**R44 SERVICE LETTER SL-69**

**R66 SERVICE LETTER SL-29**

**SUBJECT:** C627-6 Five-point Harness Assembly Lower Strap

**EFFECTIVITY:** R44-series and R66 Helicopters equipped with C627-6 Five-point Harness Assemblies delivered prior to 15 February 2019. Also, spare harness assemblies shipped prior to 15 February 2019.

**FIGURE 1**

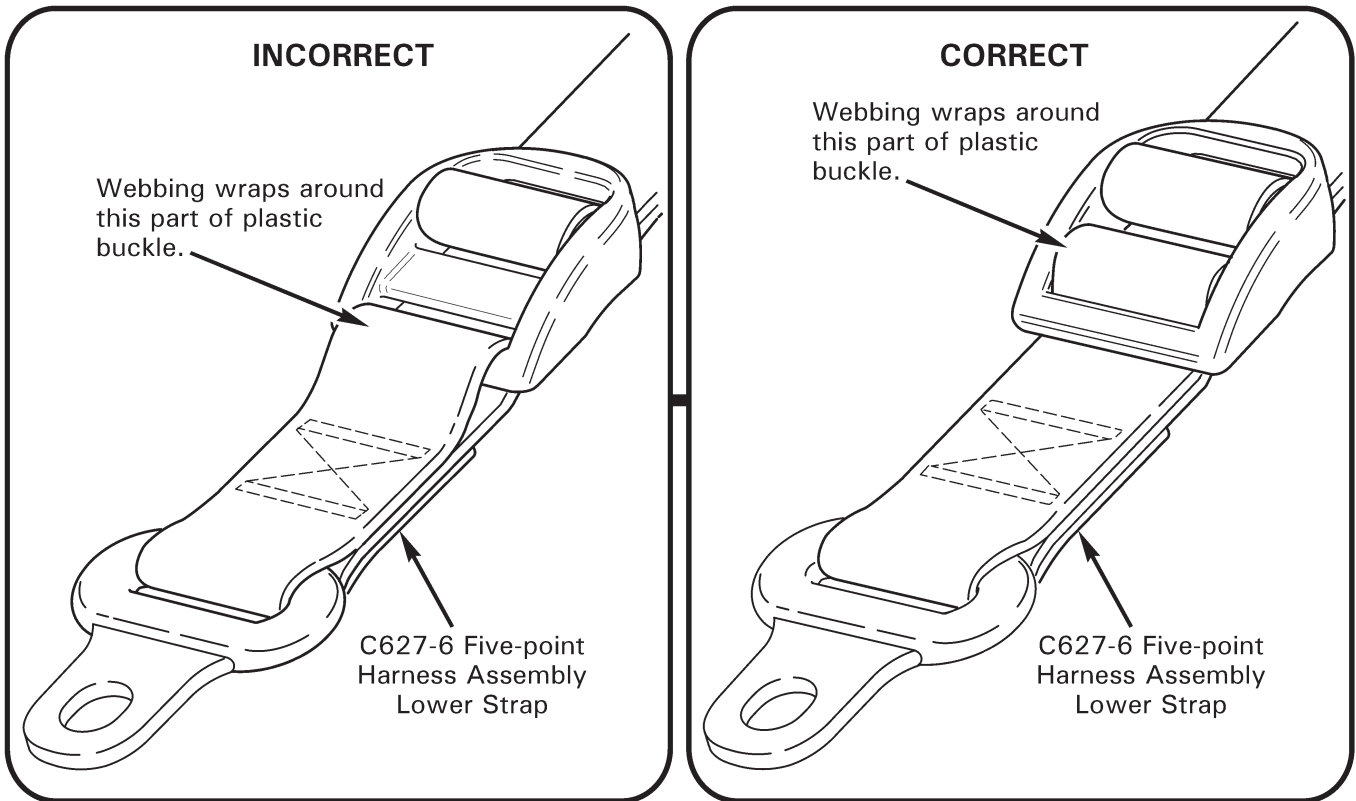
**BACKGROUND:** RHC has determined that the plastic adjusting buckle on the lower strap of C627-6 Five-point Harness Assemblies may have the webbing routed improperly. As a result, tightening the adjustment may crack the plastic buckle. Incorrect parts should be replaced to ensure that proper adjustment is available to the occupants.

1. Refer to Figure 1. If lower strap of C627-6 Five-point Harness Assembly is assembled incorrectly, order one AmSafe p/n 5134-2010111747 Lower Strap from RHC Customer Service.
2. Refer to Figure 2. Remove incorrect lower strap and install correct lower strap using existing hardware as shown. Verify security.
